P93-129 - 4TH AVENUE GARAGE

- REQUEST:
- A. Variance to allow a second floor on a detached accessory structure containing 944 square feet on 0.11 ± developed acres in the Standard Single Family (R-1) zone.
 - B. Variance to increase the rear yard lot coverage for a detached accessory structure from 25 to 46 percent.
 - C. Variance to reduce the maneuvering area behind a garage from 26 feet to 22 feet.
 - D. Variance to increase the maximum allowed wall height for a detached accessory structure from 10 feet to 15.5 feet.

SUMMARY/RECOMMENDATION: The applicant proposes to demolish an existing single car garage and construct a 944 square foot, two car, detached garage with a second story on 0.11 ± developed acres. In order to meet the applicant's objectives, the project requires the discretionary planning entitlements described above. In evaluating the project, the basic issues are the height of the structure and compatibility of design. **Staff recommends approval of the variances subject to conditions.** This recommendation is based upon existing circumstances in the alley and previous recommendations on other variances for detached structures.

PG3-129
 October 14, 1993
 EXHIBIT C-1

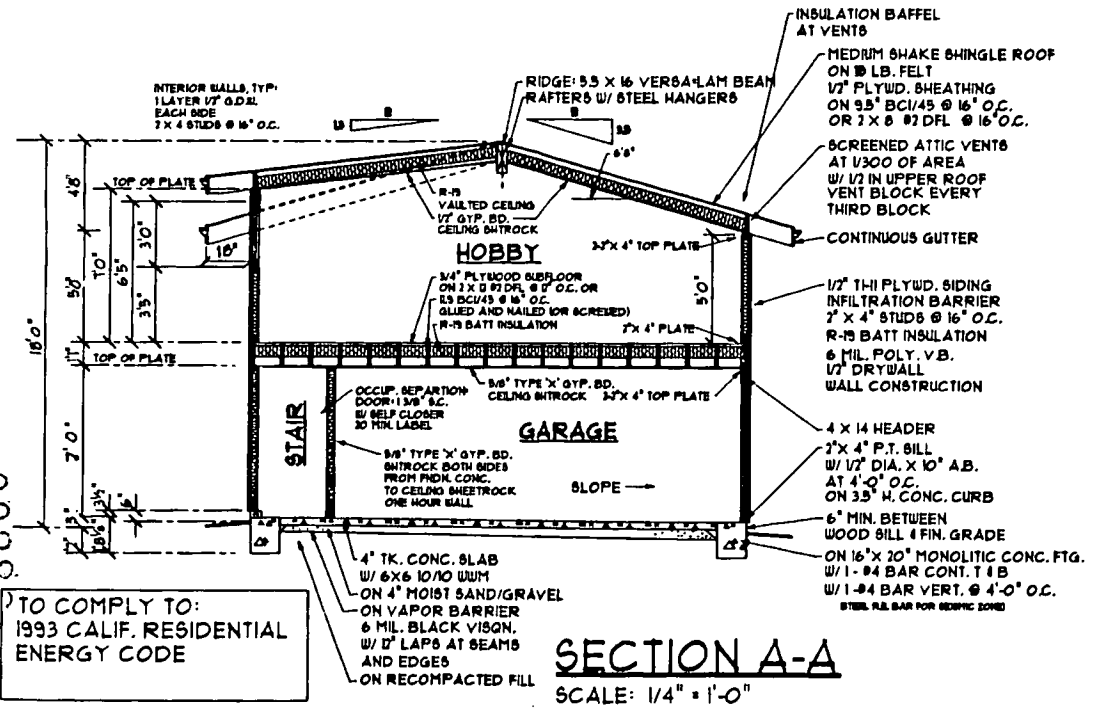
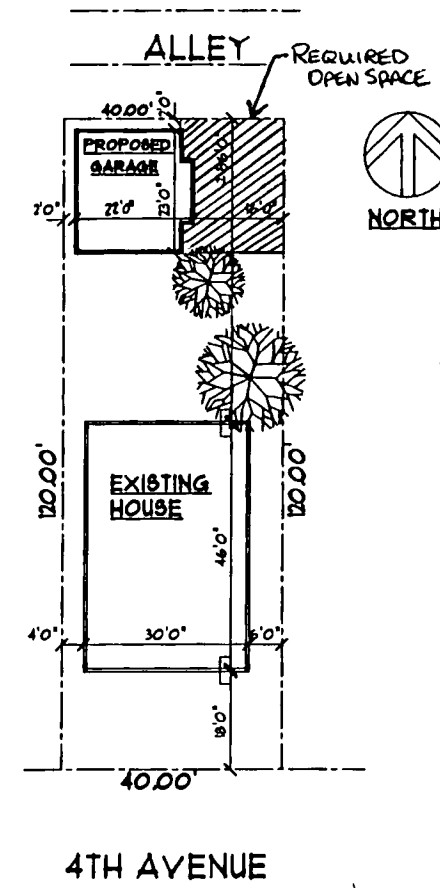
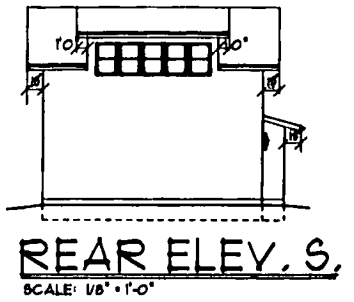
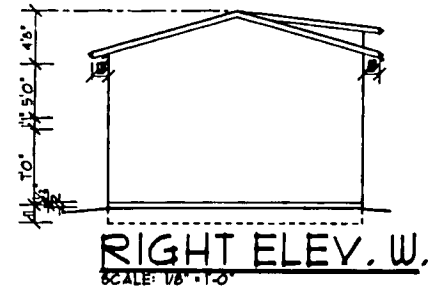
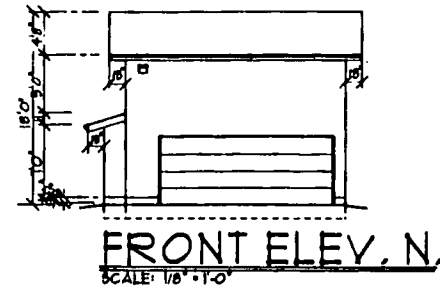
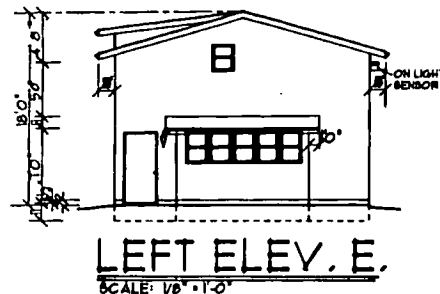
Lot Coverage: The applicant has requested a variance to exceed the maximum 25 percent rear yard lot coverage. The proposal covers 46 percent of the rear yard (last 15 feet). Meeting the 25 percent requirement would only allow a single car garage. Staff has no objection to the increase in rear yard lot coverage. There is adequate outdoor area to compensate for the loss of area within the last 15 feet. Staff suggests the applicant maintain adequate open space on the lot (see Exhibit C-1) to compensate for the loss within the last 15 feet.

- A. The site shall maintain the required open space as indicated on Exhibit C-1.
 - B. The applicant shall submit revised elevations for review and approval of Planning staff prior to the issuance of Building Permits. The revised elevation shall be similar to Exhibit C-4 and include:

EXHIBIT C-3
October 14, 1993

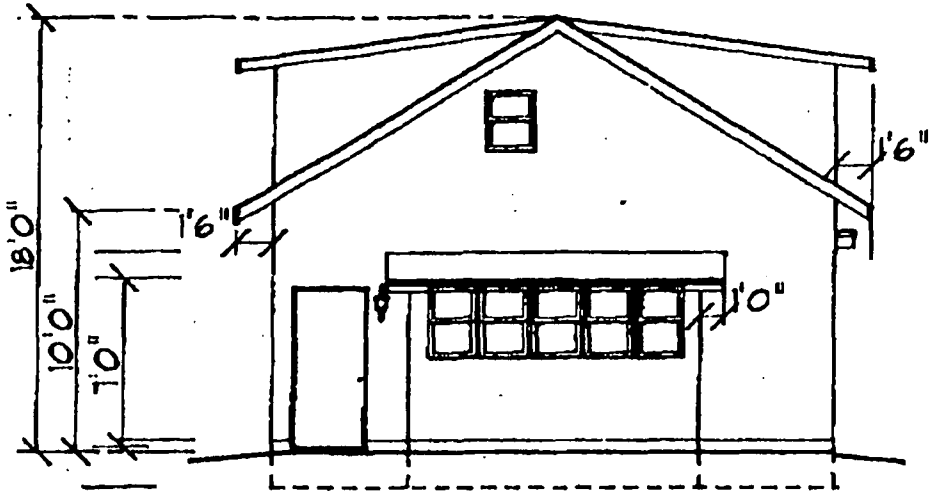
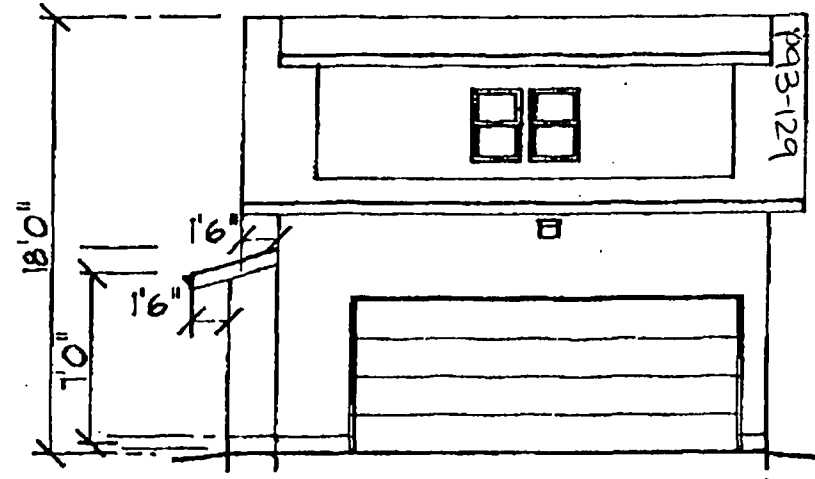
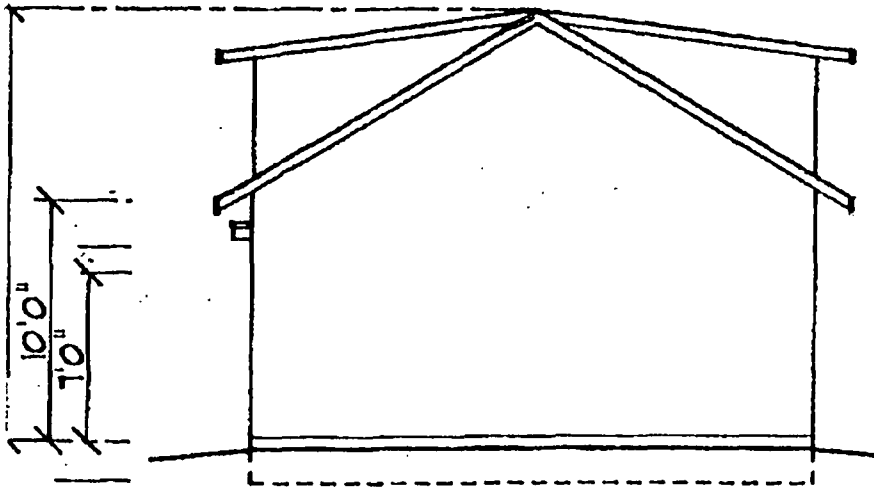
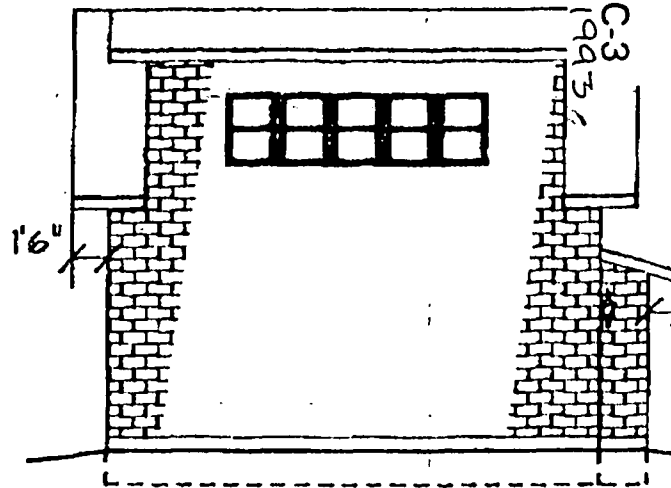
Height: The applicant is requesting a variance to allow a second floor on the detached garage. In order to accomplish this, the applicant is also requesting a variance to allow the wall height to exceed the maximum 10 feet. Staff has no objection to the variance to allow a second floor. The

second floor is not going to be used as a living area (i.e., bedroom). It is only a hobby room for the residents of the existing single family home. Staff does object to the increased wall height as shown on the applicant's elevations. The approval of the second floor on the detached garage should only be allowed if the structure can meet the height requirements of the Zoning Ordinance. Staff has suggested the necessary ceiling height for the second floor be accomplished using dormers similar to Exhibit C-4, leaving the first plate line at the maximum 10 feet, and the second plate line of the dormers at 14 feet. The applicant proposed a dormer which covered all but 18 inches on either end of the building. The dormer should inset a minimum of two feet from the main wall. Other garages have had approved variances for second floors while not exceeding the maximum wall height. Staff recommends approval of the variance to increase the wall height and allow the second floor, provided the design be revised similar to Exhibit C-4.

The applicant is proposing to construct the detached garage using a medium shake shingle roof with T1-11 plywood siding. The existing residence has a shake roof with shingles used as the exterior material. The existing residence also has a very steep roof. The applicant's proposed design does not adequately complement the existing roof pitch of the residence. Meeting the wall height of 10 feet and maintaining the maximum height of 18 feet, will better accomplish complementing the existing design of the house. As described in the Height section, the dormer should be redesigned similar to Exhibit C-4.
